**PLEASANT PRAIRIE PLAN COMMISSION MEETING  
VILLAGE HALL AUDITORIUM  
9915 39<sup>th</sup> AVENUE  
PLEASANT PRAIRIE, WISCONSIN  
6:00 P.M.  
JULY 13, 2015**

**PLEASANT PRAIRIE PLAN COMMISSION MEETING  
VILLAGE HALL AUDITORIUM  
9915 39TH AVENUE  
PLEASANT PRAIRIE, WISCONSIN  
6:00 P.M.  
June 8, 2015**

PROJECT NAME  
**Durrani Office**

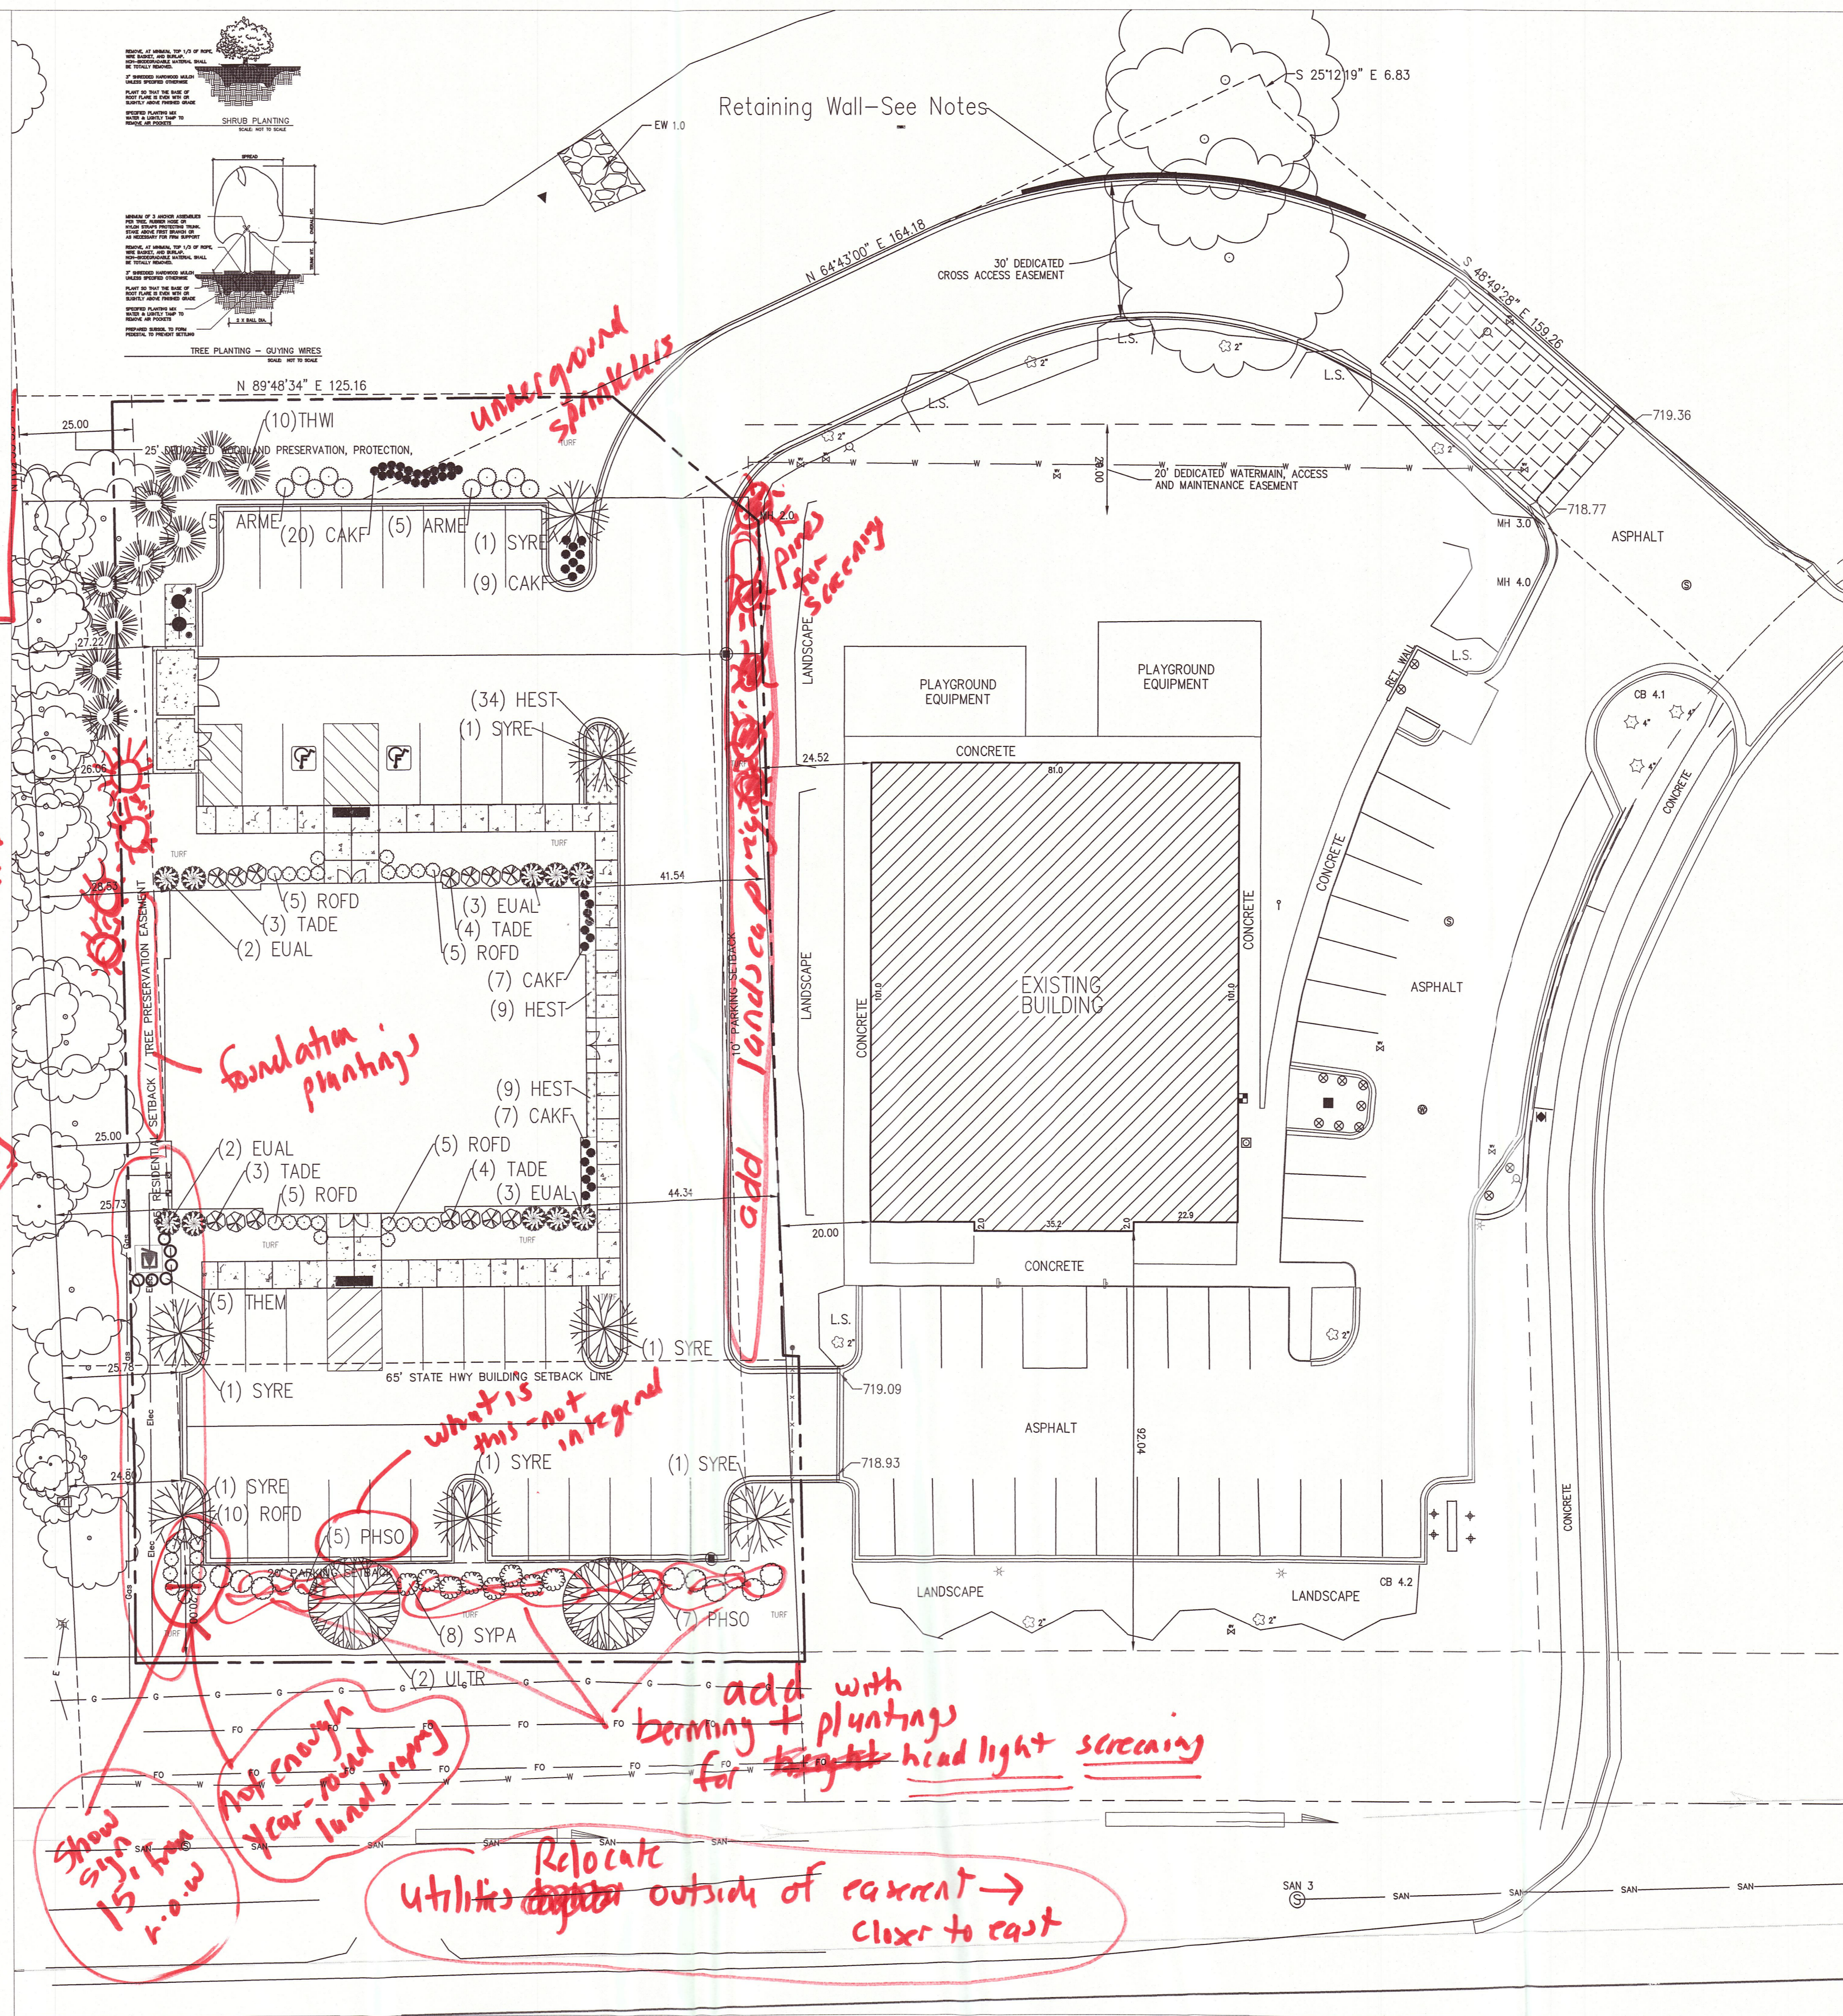
- underground sprinklers
- add landscape pines for screening
- add landscape pines for screening
- add with berming + plantings for height head light screening
- Relocate utilities outside of easement -> closer to east
- Not enough year-round lawn irrigation
- show sign 15' from r.o.w
- show off-site fencing
- foundation plantings
- what is this not integrated
- fence?

PROJ. MGR: MDE  
 DRAFTED: NDB  
 DATE: 06-10-15  
 CHECKED: MDE  
 DATE: 06-10-15  
**2012.0137.08**  
 SHEET  
**C-2**

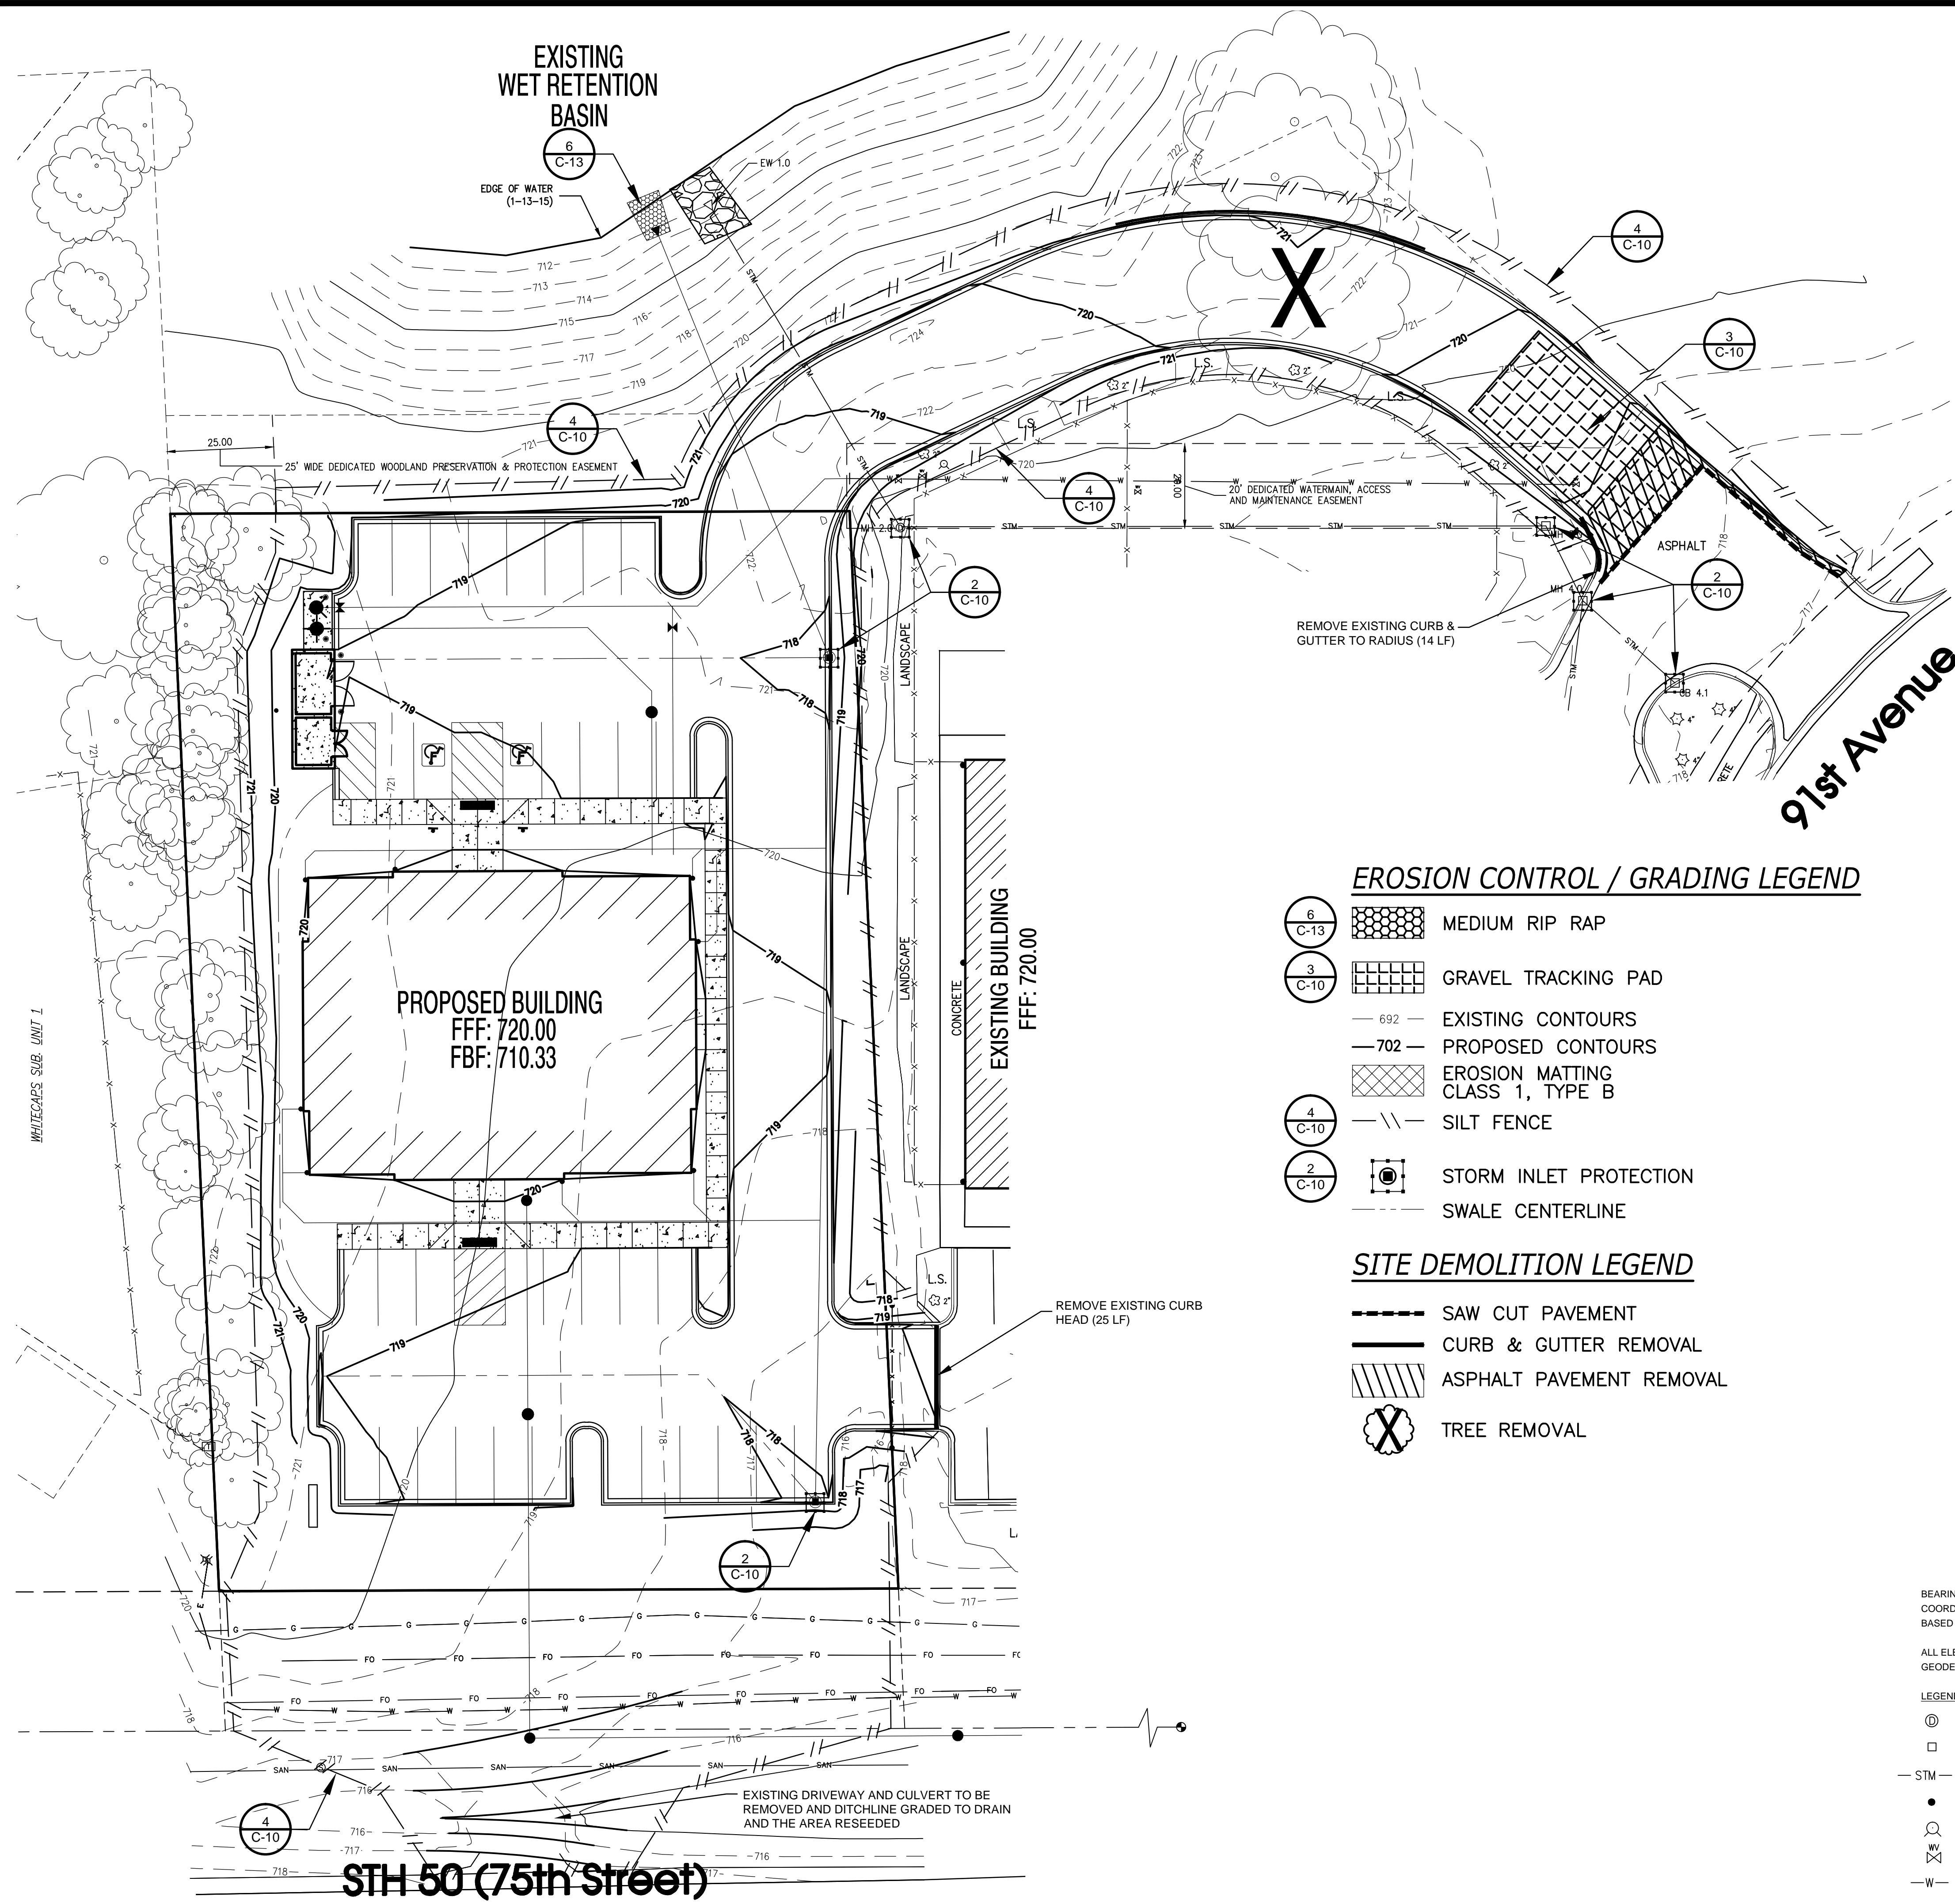
- h. On the existing Conditions (Sheet C-2):
  - i. Label the existing sanitary sewer manholes identified in the Existing Utility Data table. Also, identify / distinguish the Kenosha Sanitary Sewer versus the Pleasant Prairie Sanitary Sewer.

**2012.0137.08**  
SHEET  
**C-4**

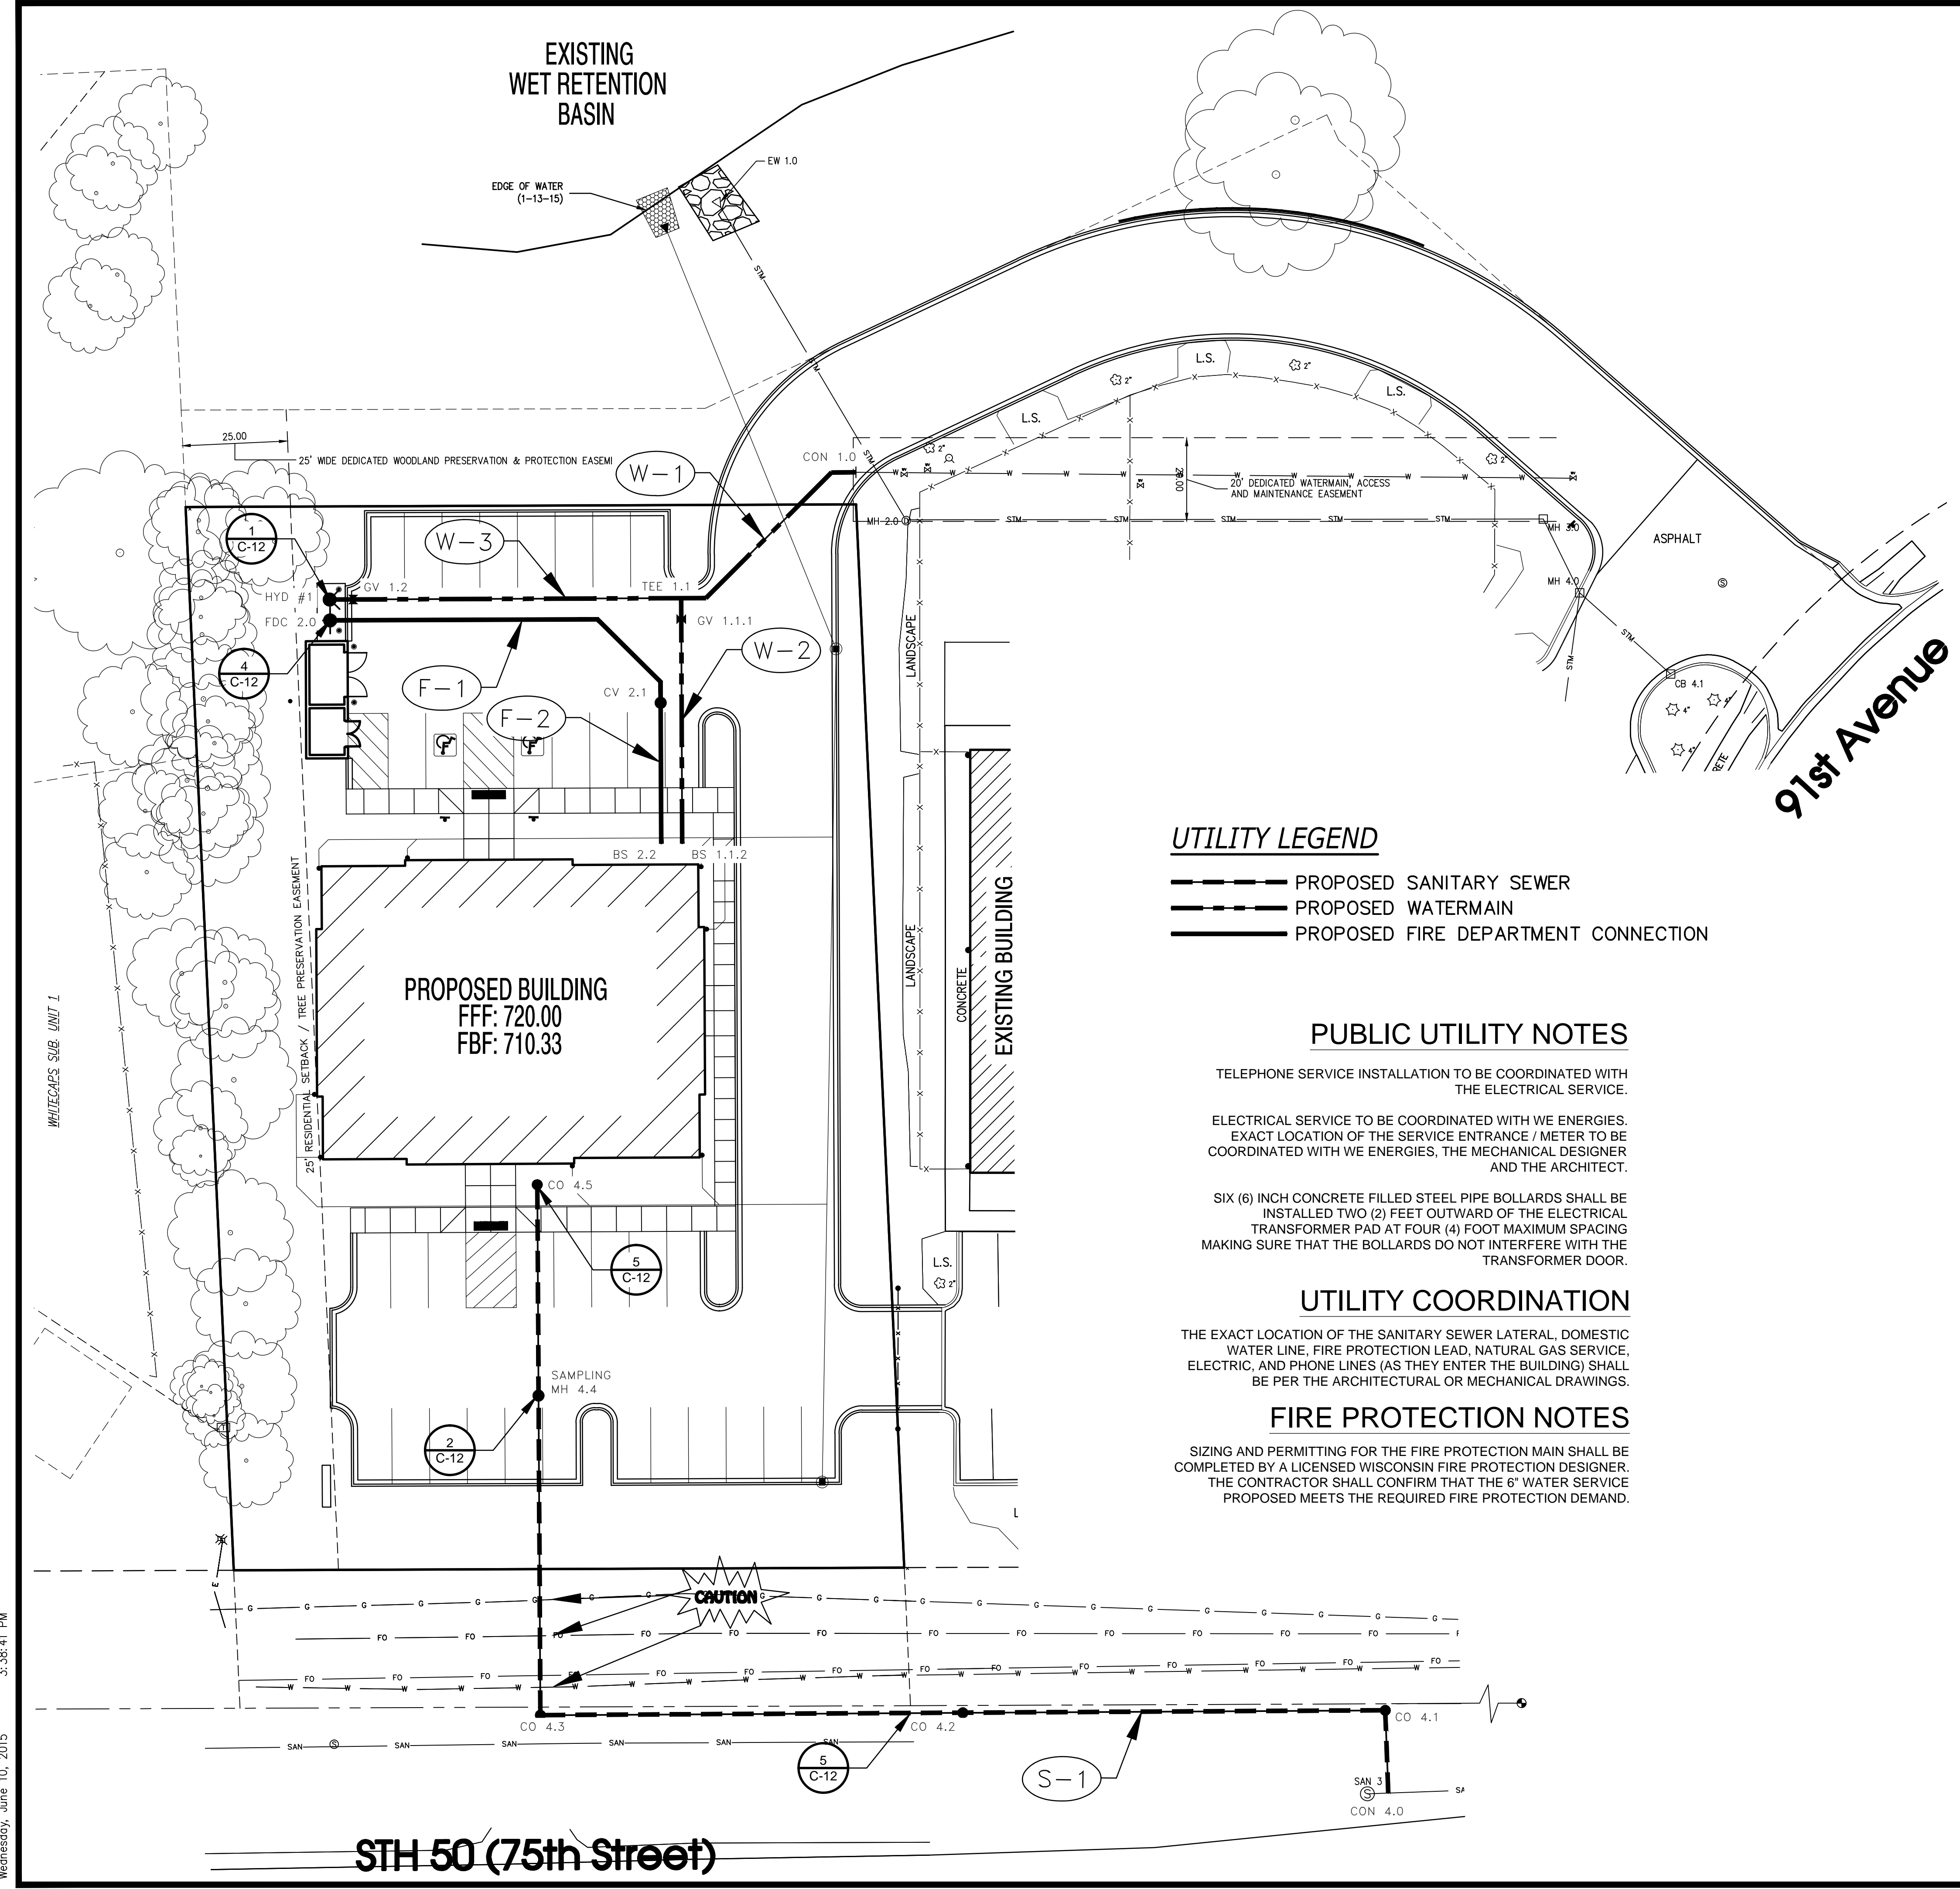
- iii. Written permission/right-of-entry must be obtained from the Goddard School for the proposed work on their property.
- j. On the Site Grading, Drainage & Erosion Control Plan (Sheet C-4):

- ix. Adjust location of the cross access gate so that the entire gate is located on Dr. Durrani's property.
- k. On the Pavement Grading Plan (Sheet C-5):
